Addendum 2

RFQMA24 – 5082

Nahani Way Public School - Window Replacement

**REFERENCE: 2024 WINDOW REPLACEMENT
NAHANI WAY PUBLIC SCHOOL
235 NAHANI WAY, MISSISSAUGA, ON**

1
A1 FIRST FLOOR PLAN
 SCALE: NTS

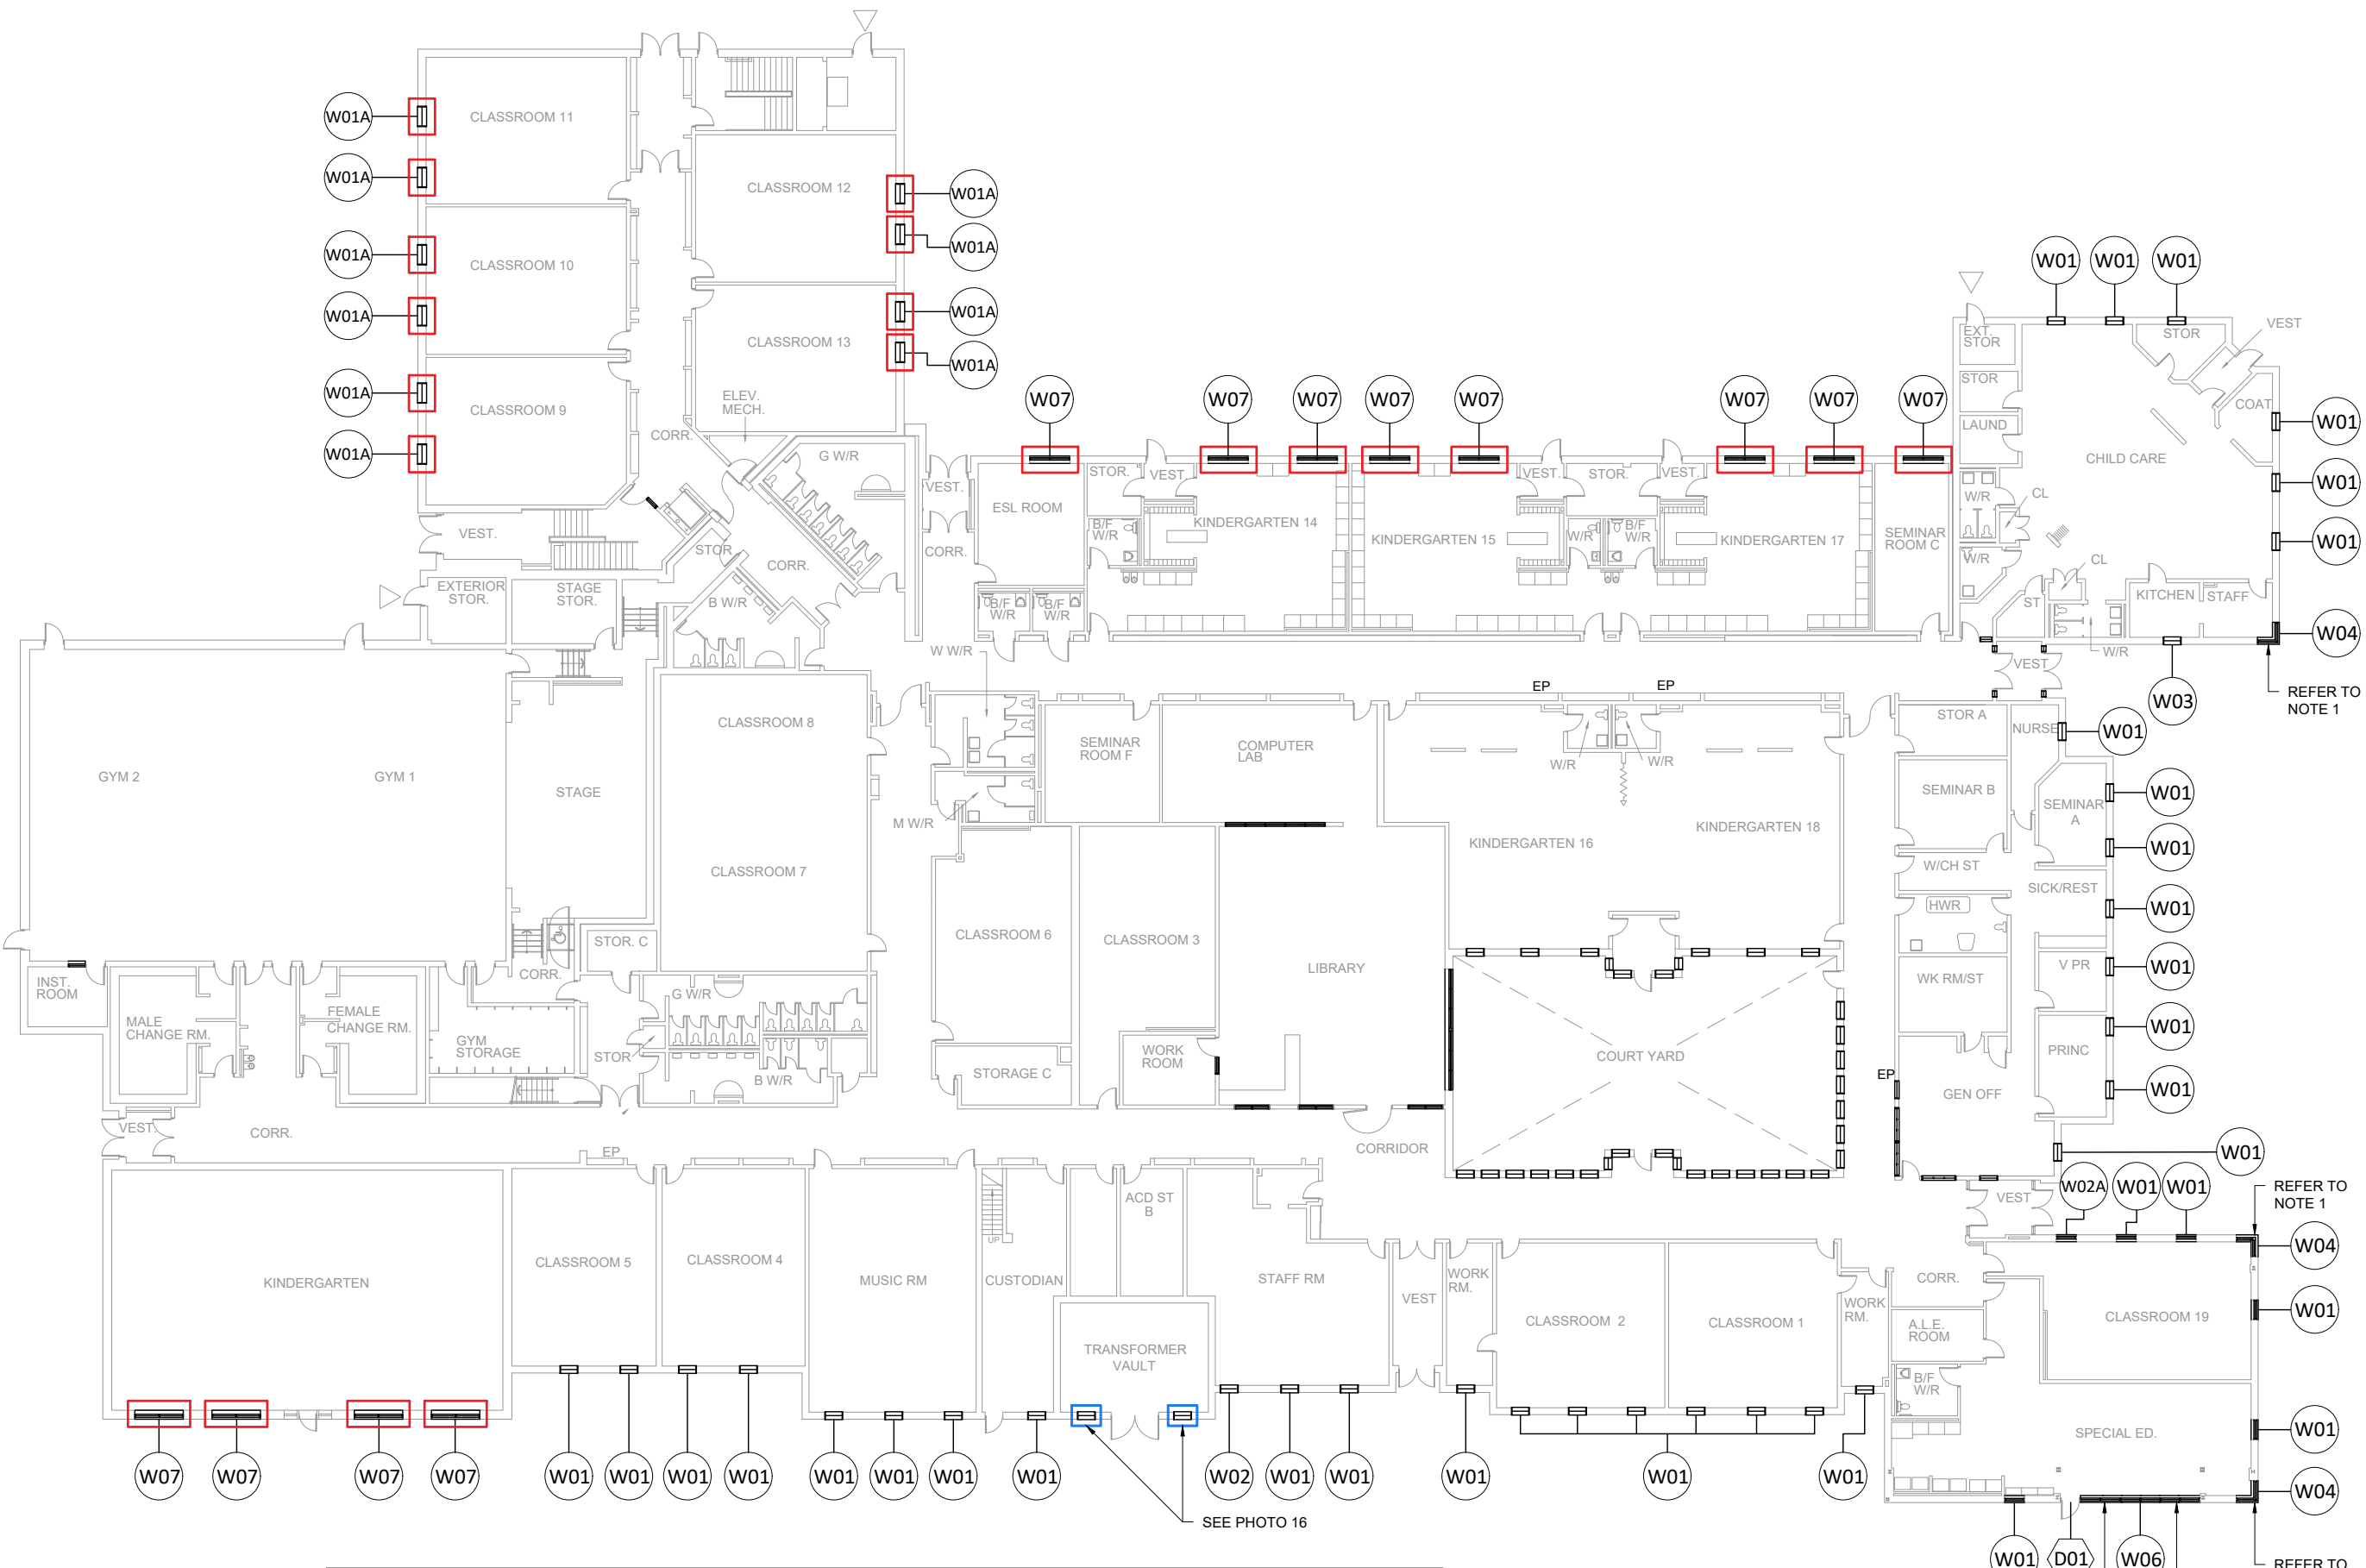
Please confirm if window/ vent perimeter caulking replacement is exterior only or interior as well.

The caulking replacement is limited to the two (2) louvers as indicated on the revised drawings. This addendum 2 includes for Contractors to price the replacement of additional windows that were not included on the original scope of work, therefore no additional caulking replacement for windows will be included as the replacement of the windows includes all caulking originally required at these areas.

1
A8 NEW WINDOW HEAD AND SILL DETAIL 1
SCALE: 1 1/2"=1'-0"

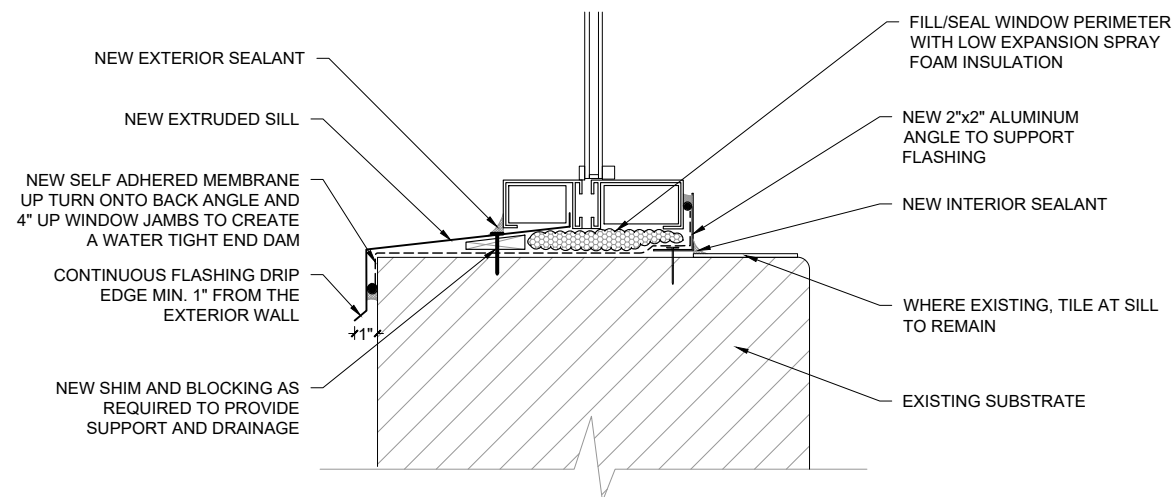
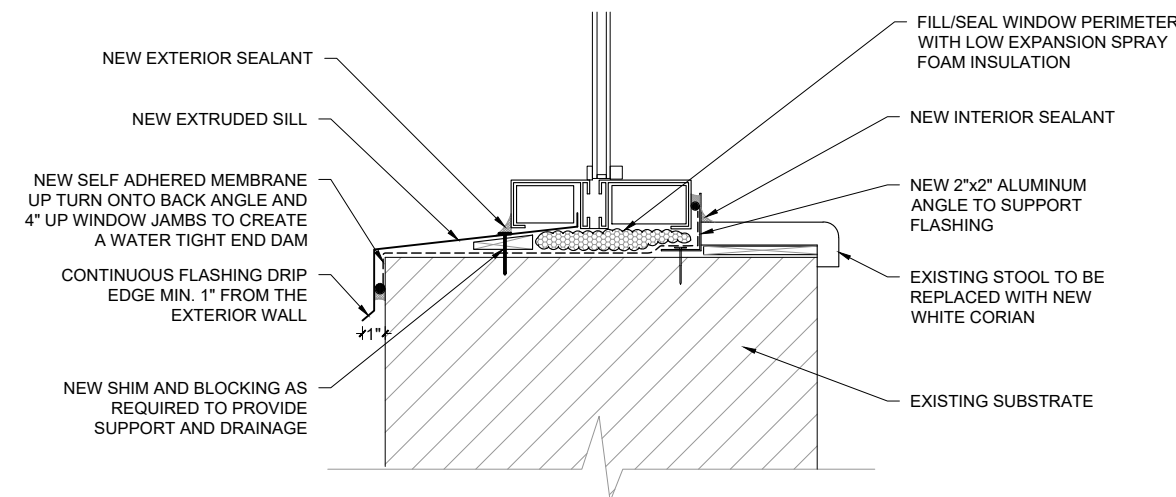
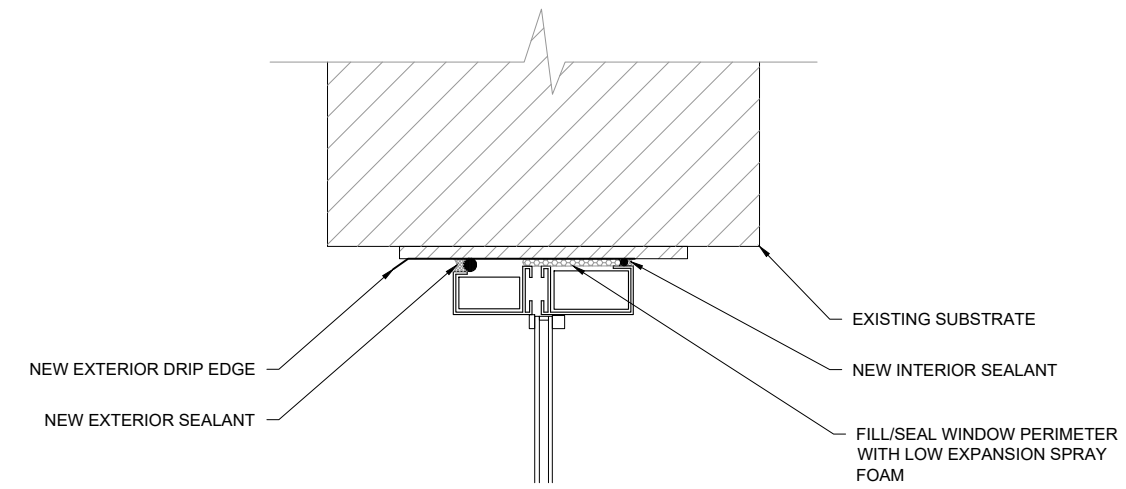
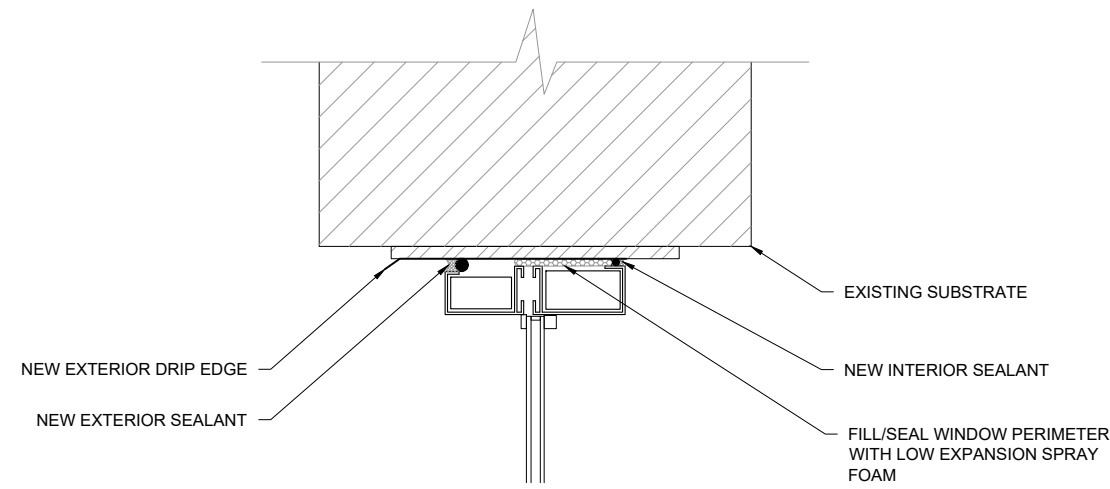
Please confirm which window types are header/ sill detail 1 and which are header/ sill detail 2.

Please see revised drawings attached to this addendum indicating which window types are represented under the two indicated header / sill details at drawing A8 details 1 and 2. See also detailed callouts at the window elevations on Drawings A3 and A4.
